INVITATION TO BID RESERVE AT HUDSON CROSSING PUBLIC IMPROVEMENTS– ADDENDUM #1
March 1, 2019

Engineering Plans
for
the Village of Oswego

Project No.:	SH0002
File Name:	83_LS_PLAN.dgn
Issue Date:	3/1/2019
Scale:	1" = 30'
Sheet Number	83

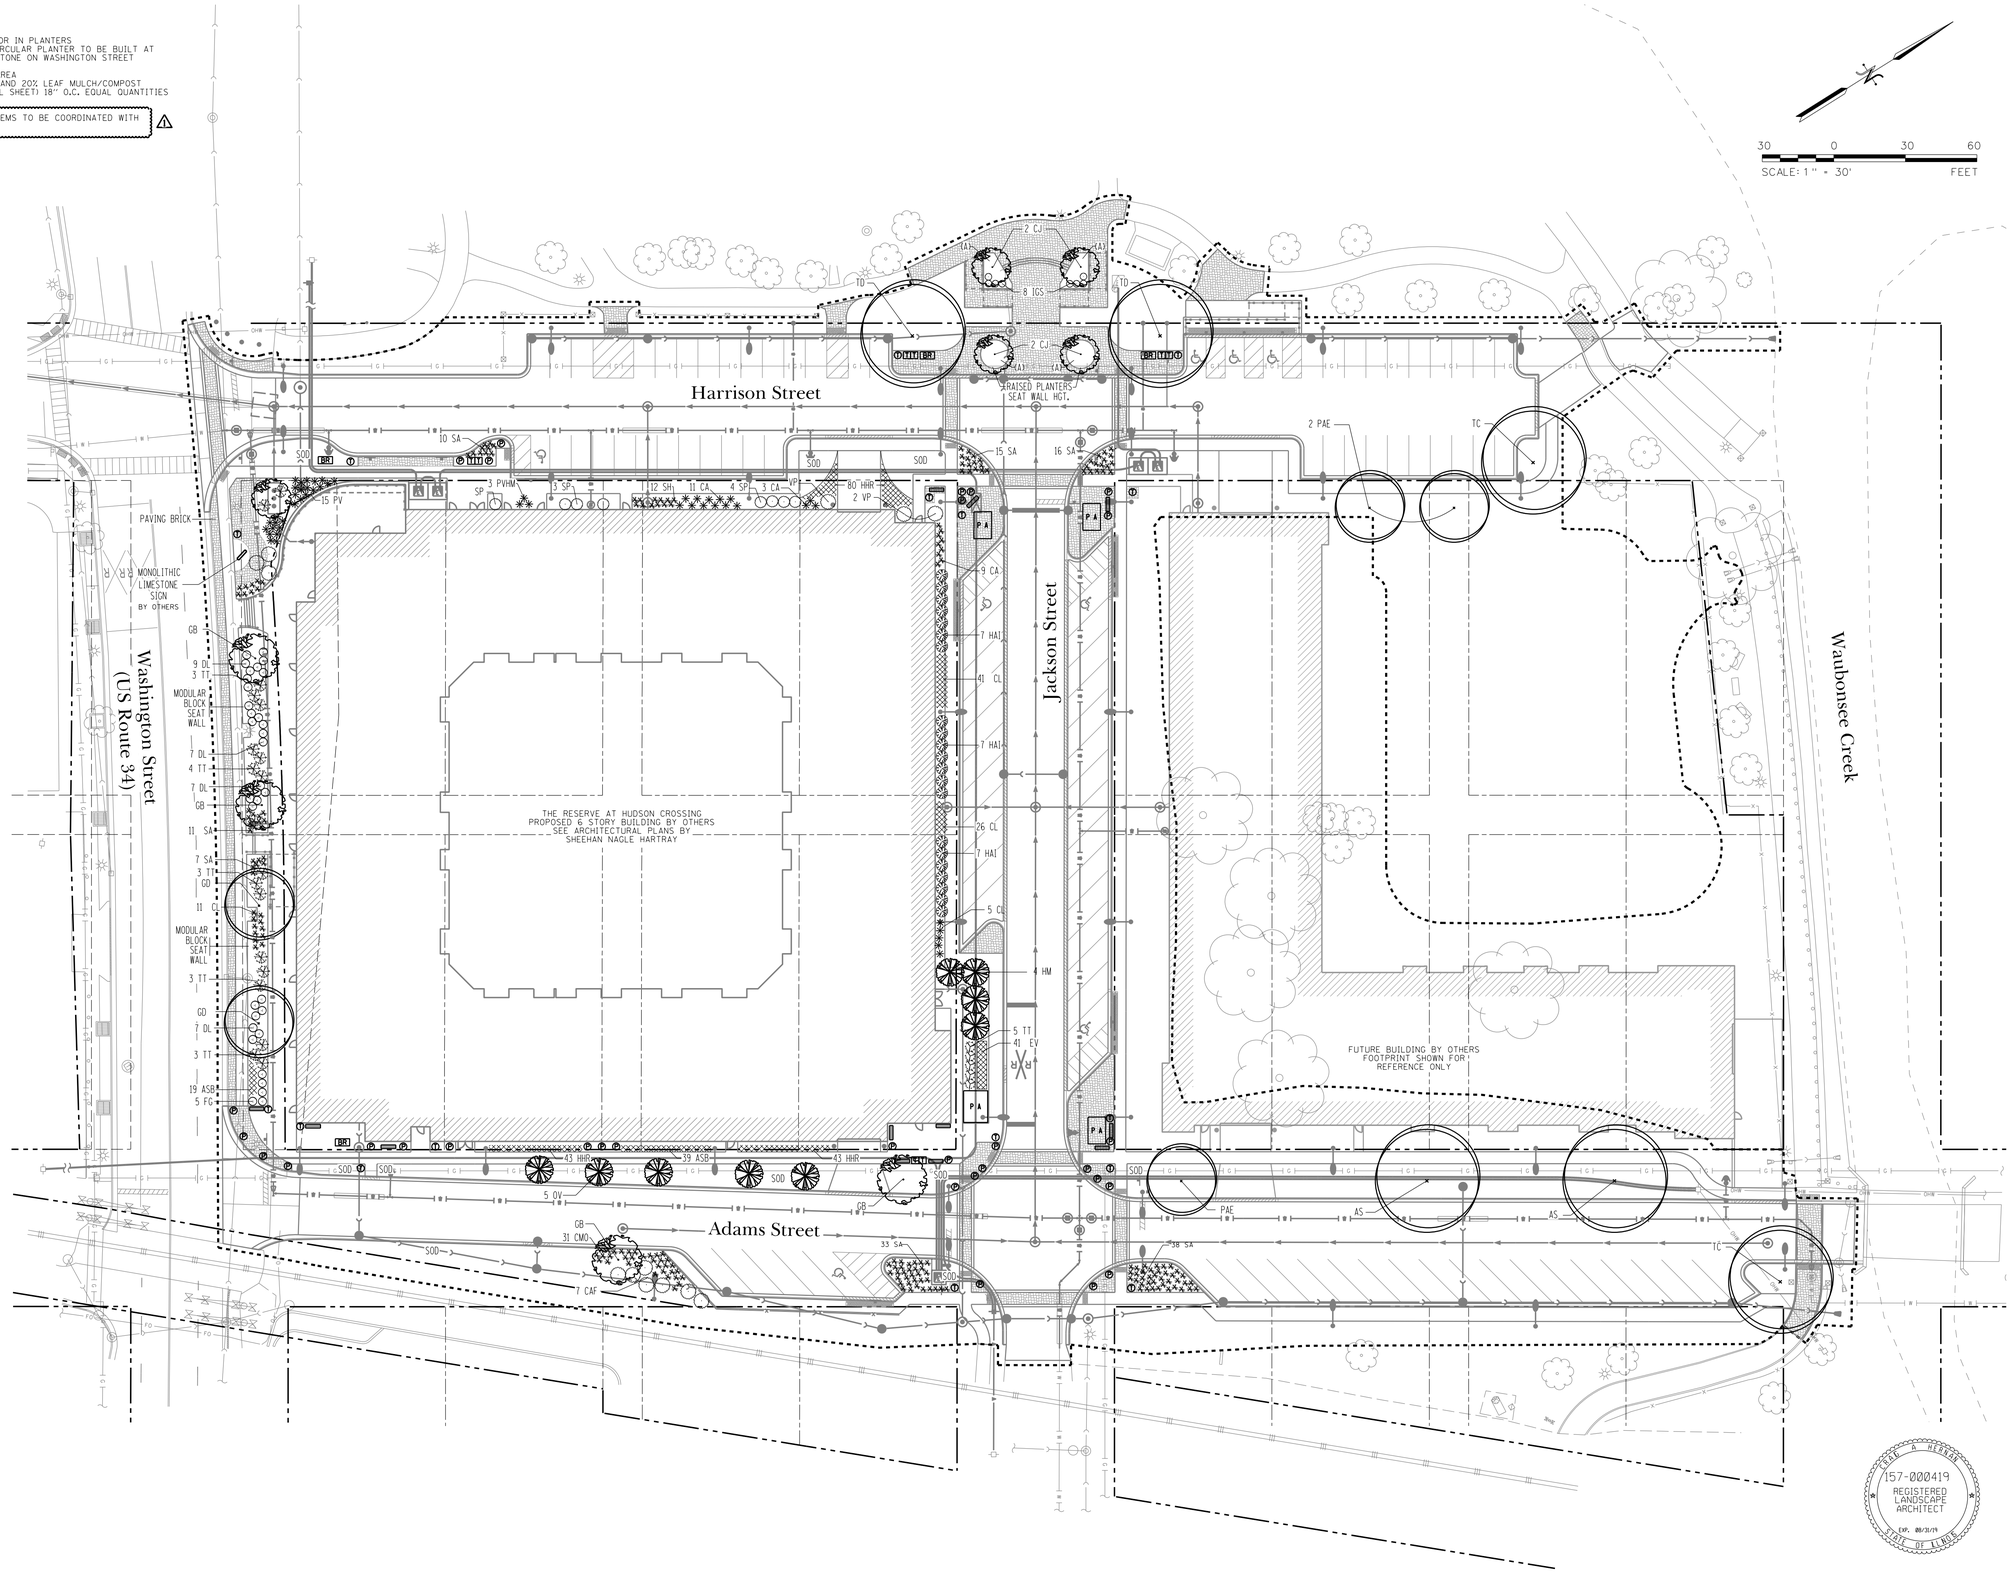
24. Sheet No. 83 – Landscape Plan
    A. Added Note # re: final location of all landscape items to be coordinated with Village of Oswego.
    B. Added Bike Rack symbol to legend and plan.
